For: Self-Route Expandable Multi-Memory Packet Switch with Distributed Scheduling Means

Serial Number: 09/683,429

Response and Amendment Under 37 C.F.R. §1.111
And Petition for One Month Extension of Time Under 37 CFR 1.136(a)(1)

FIG. 3

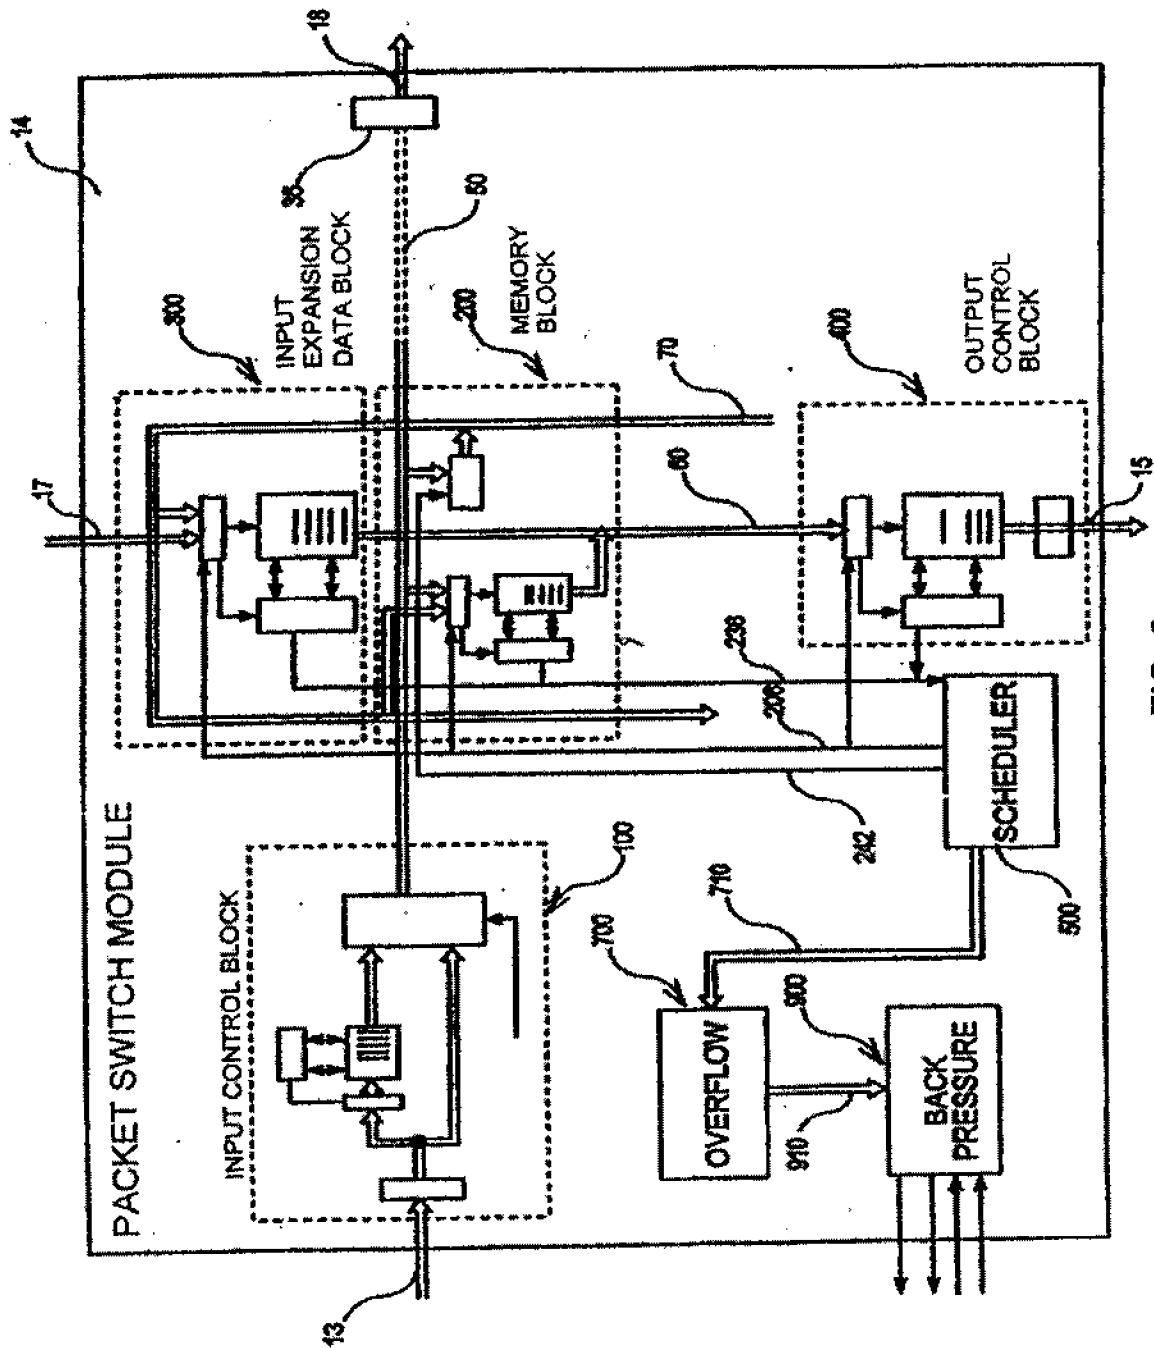
The Office Action stated an objection to Figures 3-8 as failing to comply with 37 CFR 1.121(d) because descriptive labels necessary for understanding the drawings are missing. The Office Action also stated that the quality of the connections shown on Figure 8 is not acceptable. A proposed set of drawings to overcome the objections is attached to this amendment as Appendix A. Each sheet has been labeled "Replacement Sheet" to be in compliance with 37 CFR 1.121(d).

each memory block associated with one of said cross points ...”. Support for Applicants’ claim 1, as amended, can be found, for example, in paragraph 0025 and Figure 3.

FIG. 8

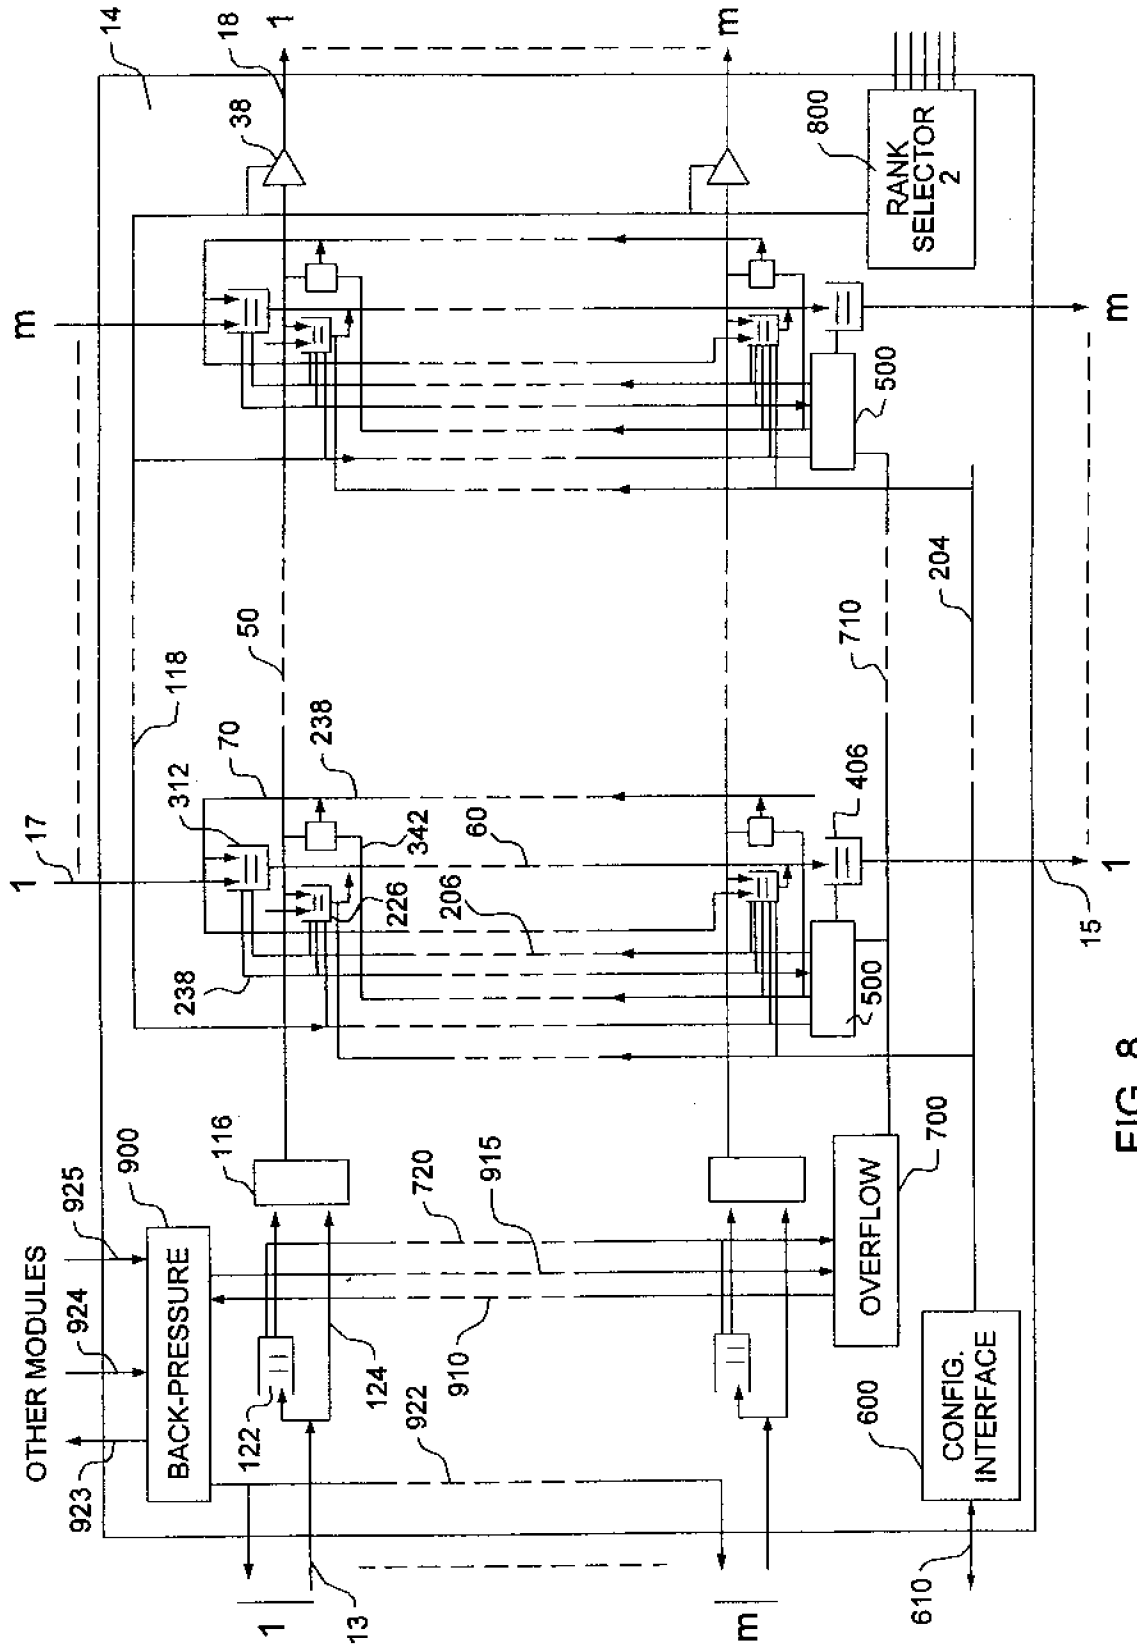
Applicants respectfully submit that Yamazaki does not teach or suggest the limitation of Applicants’ claim 1, as amended, of “...a plurality of schedulers, each scheduler associated with one of said output ports ...”. Support for Applicants’ claim 1, as amended, can be found, for example, in paragraphs 0008, 0026, 0051, 0052 and Figures 3 and 8.
